9.5 Other Auxiliary Systems

The information in this section of the reference ABWR DCD, including all subsections, tables, and figures, is incorporated by reference with the following departures and supplements.

Figure 9.5-3 Lower Drywell Flooder System Arrangement/Configuration

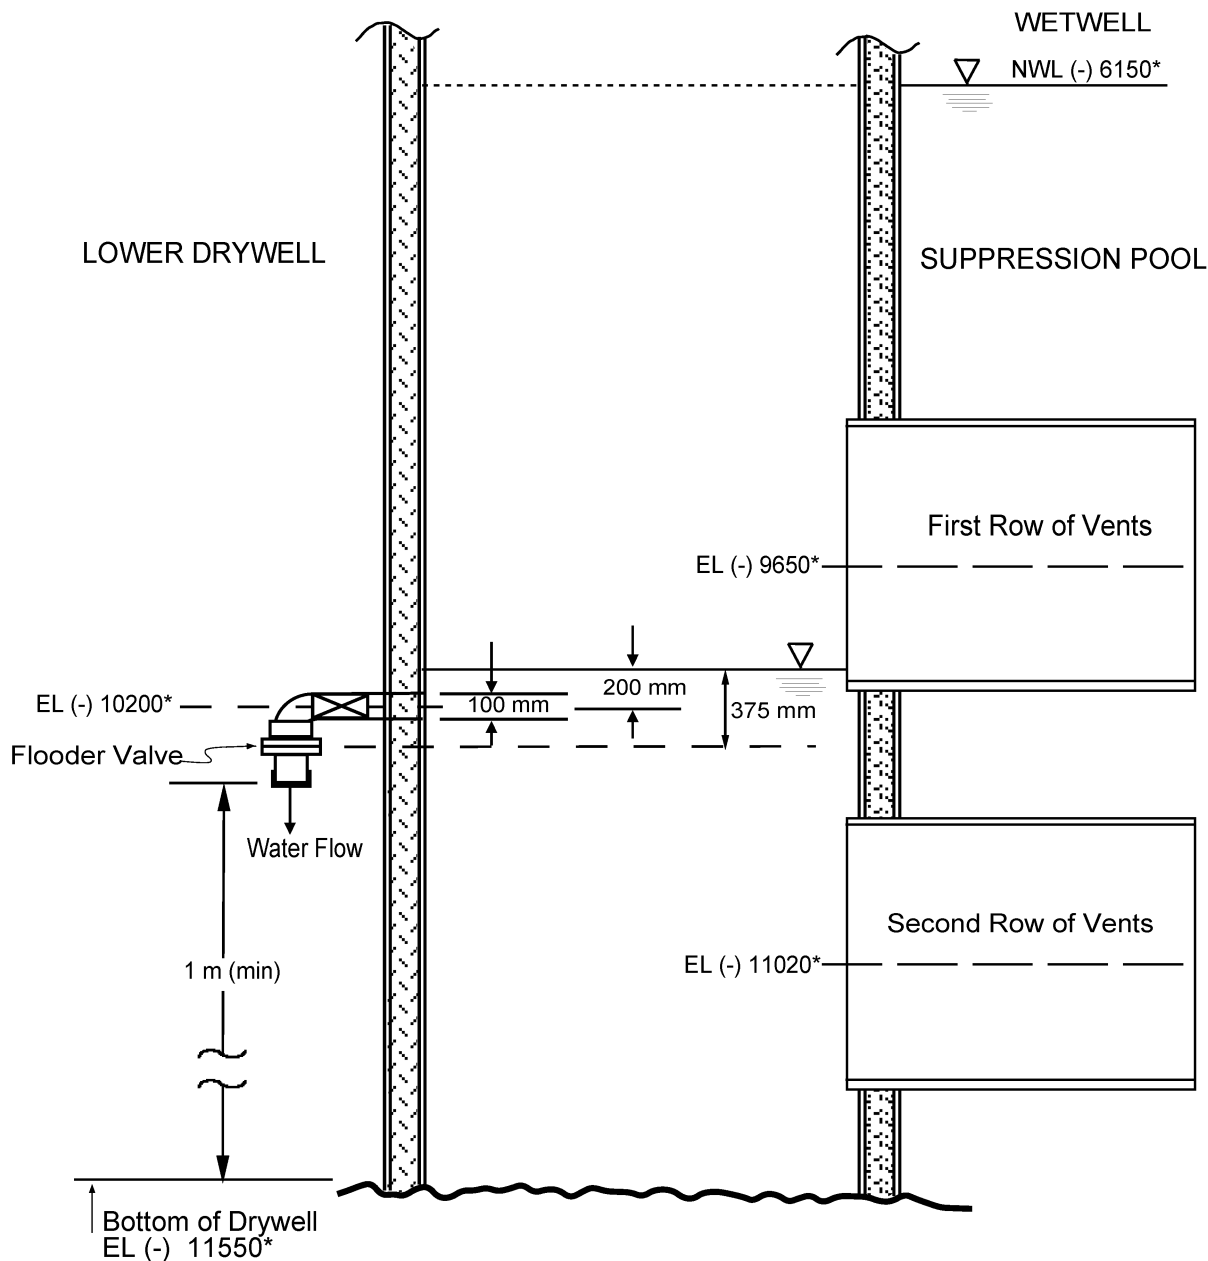
| STD DEP 9.5-2 (Figure 9.5-3, replaced entire figure) | STD DEP Admin |

The LDF, shown schematically in Figure 9.5-3, provides a flow path for suppression pool water into the lower drywell area during severe accident scenario that leads to core meltdown, vessel failure, and deposition of molten corium on the lower drywell floor. Molten corium is a molten mixture of fuel, reactor internals, the vessel bottom head and control rod drive components. The flow path is opened when the lower drywell airspace temperature reaches 260°C ± 10°C.

The LDF consists of ten pipes that run from the vertical pedestal vents into the lower drywell. Each pipe ~~contains~~ has an isolation valve and a fusible plug valve connected to the end of the pipe that extends into the lower drywell ~~by a flange~~. The fusible plug valves open when the drywell air space ~~(and subsequently the fusible plug)~~ temperature reaches 260°C ± 10°C. When the fusible plug valves open, a minimum of 10.5 L/s of suppression pool water will be supplied through each floodor pipe (105 L/s total) to the lower drywell to quench the corium, flood the lower drywell and remove corium decay heat, which is estimated at 1% of rated thermal power. The flow rate is based on a minimum hydrostatic head of 200 mm above the floodor pipe inlet centerline and takes the frictional losses through the floodor pipe and fusible plug valve into account.
